ENERGY STAR® Residential Swimming Pool Pump Specification Framework

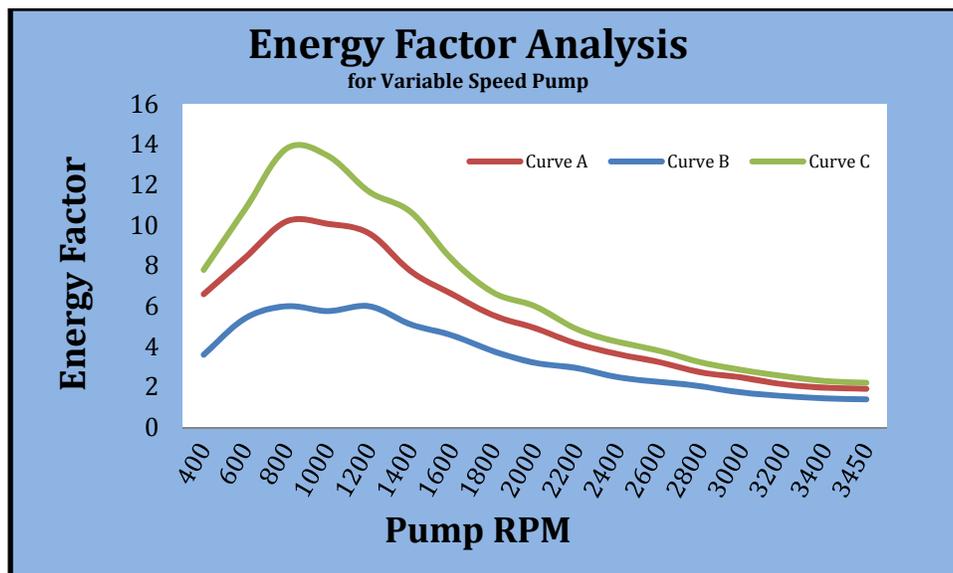
Below is a chart showing energy factor as it varies with speed for a specific pump model. After reviewing the CEC database, most every manufacturer of variable speed pump have chosen a voluntary data point that reflects a high performing energy factor. For all manufacturers, this best point occurs between ~800 rpm and ~1200 rpm. This appears to be a "sweet spot" for energy factors and pump performance, and it also is the typical range where these pumps operate in the field for the daily filtration cycles. It is recommended that a data point in this RPM range be reported to better reflect the pump's operation in a typical application.

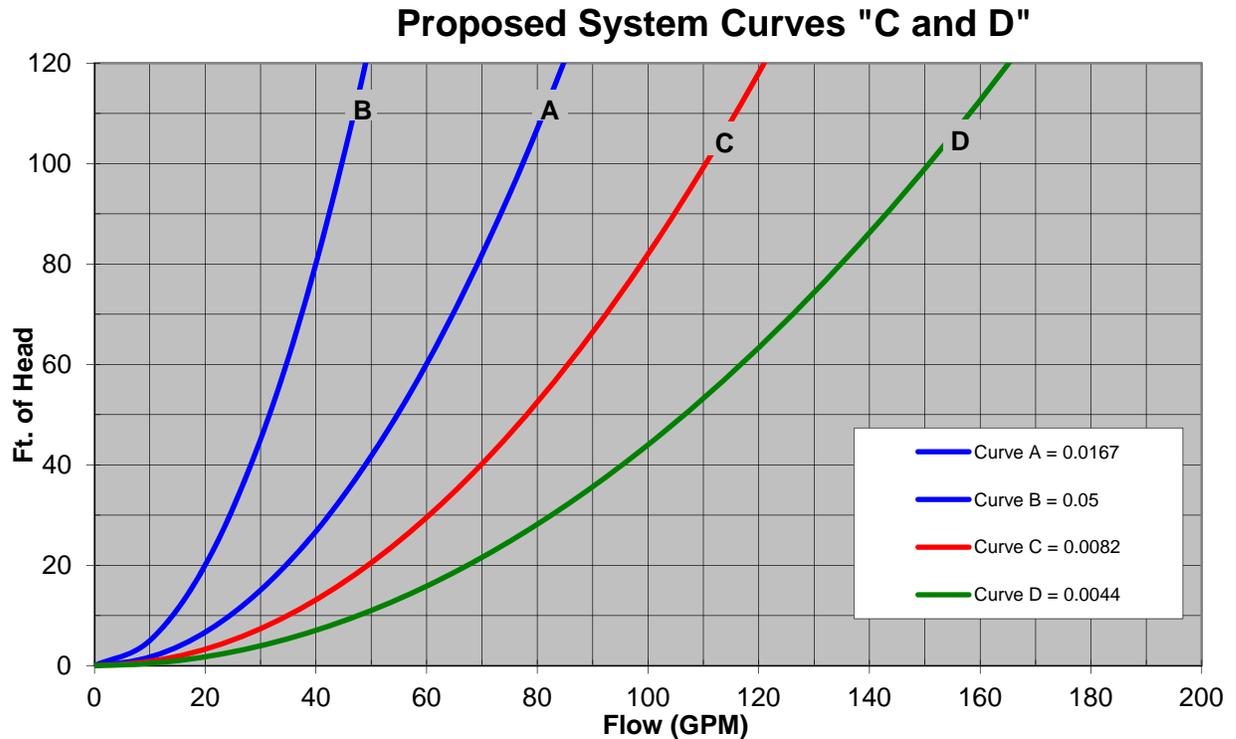
Background - Initially CEC-T20 called for only curves A and B. It was the pool industry that requested the addition of curve C to better reflect current construction techniques. The APSP-10 sub-committee responsible for determining the Curve C coefficient of **0.0082**, also strongly considered at that time requesting a fourth curve D with a coefficient of **0.0044** to reflect the hydraulic conditions of larger pools typically constructed with large piping, fittings, and equipment and very low TDH. There are products

from many manufactures currently available that are designed and optimized for these higher flow rates and lower TDH systems needed for these larger pools and the curve D performance reflects their superior savings potential. This may be the appropriate time to expand the data collection to include curve D since much of the products are likely to be re-tested to meet the stringent new test procedures.
